Groundwater Application Review Summary Form

Application # G- 18983

GW Reviewer Travis Brown Date Review Completed: 8/20/2020

TO: Water Rights Section Date 8/20/2020
 FROM: Groundwater Section Travis Brown
 Reviewer's Name
 SUBJECT: Application G- 18983 Supersedes review of _____
 Date of Review(s) _____

Well Location Map

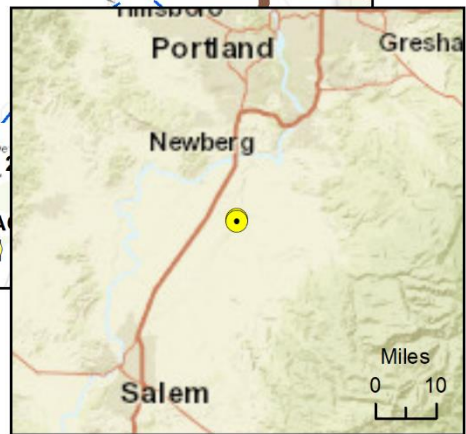
A4. **Comments:** The proposed POA/POU are ~1.5 miles east of Hubbard, Oregon.

The nearest known neighboring well to the proposed POA is MARI 1021, ~340 ft southeast of proposed POA 2 (“Well H”). MARI 1021 is an authorized POA under **Certificate 29402*** for up to 0.2 cfs of Irrigation on 24.6 acres. Although the proposed total depth (250 ft bsl) of POA 2 (“Well H”) is substantially deeper than the total reported depth (118 ft bsl) of MARI 1021, the proposed seal depth of POA 2 (“Well H”) is only 50 ft bsl; thus, it is anticipated that POA 2 (“Well H”) would produce water from the same water-bearing zones as MARI 1021. The Theis (1935) equation for drawdown in a confined aquifer was used to estimate the potential interference with MARI 1021 due to the proposed use. Results of the analysis indicate that continuously pumping POA 2 (“Well H”) at an average rate of 0.150 cfs (based on the maximum duty [73 af] distributed evenly over the irrigation season [245 days]) would likely cause less than ~25 ft of interference with MARI 1021 by the end of the irrigation season (see attached Interference Analysis). Therefore, the proposed use seems unlikely to cause injury to MARI 1021 or similar neighboring groundwater rights.

Comments: Proposed POA 1 ("Well G") is within 1/4 mile of SW 1 (Pudding River); per OAR 690-009-0040(4)(a), the Potential for Substantial Interference (PSI) is assumed.

C6. SW / GW Remarks and Conditions: **PSI was assumed because the location of proposed POA 1 was within ¼ mile of SW 1 (Pudding River); this assumption may be avoided by revising the location of POA 1 to greater than ¼ mile from SW 1 (Pudding River). Additionally, PSI was assumed because the total requested rate (0.365 cfs) is greater than 1 percent (0.16 cfs) of the applicable instream water right for SW 1 (Pudding River); this assumption may be avoided by reducing the total requested rate to 0.16 cfs or less.**

Well Statistics – 4S/1W-25 & 36

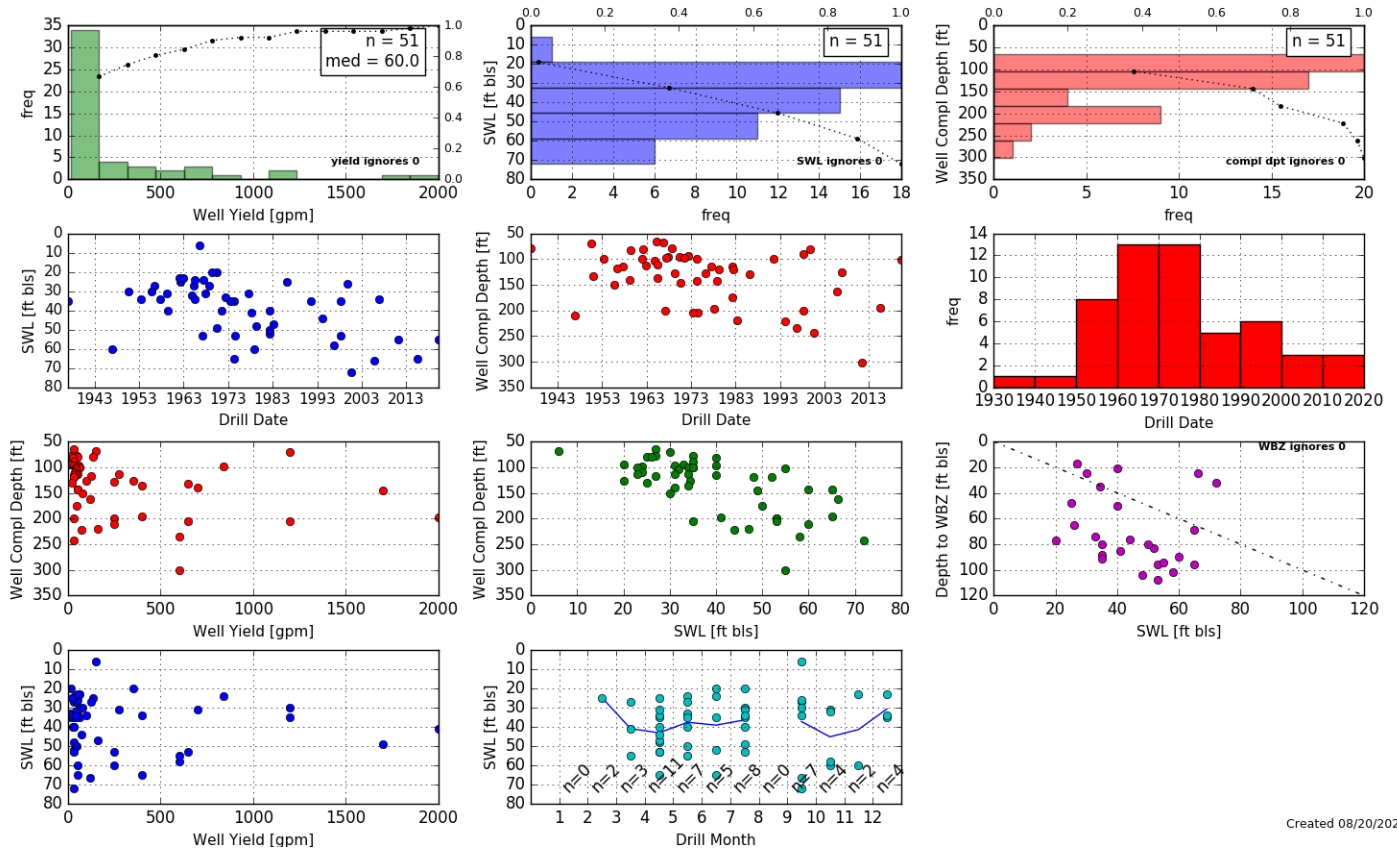
Median reported well yield near the proposed POA is ~60 gpm (~0.134 cfs), with reported yields ranging from 15 to 2000 gpm (~0.033 to 4.456 cfs) (see attached Well Statistics). To satisfy the maximum requested rate (0.365 cfs), each of the proposed POA would need to produce at least ~82 gpm (0.1825 cfs), which is well within the range of nearby reported yields. Water level information in this area is scarce. However, water levels from wells in surrounding areas indicate relative stability (see attached Hydrographs).

In order to protect senior users and the groundwater resource, the conditions specified in B1(d)(i) and B2(c) are strongly recommended for any permit issued pursuant to this application.
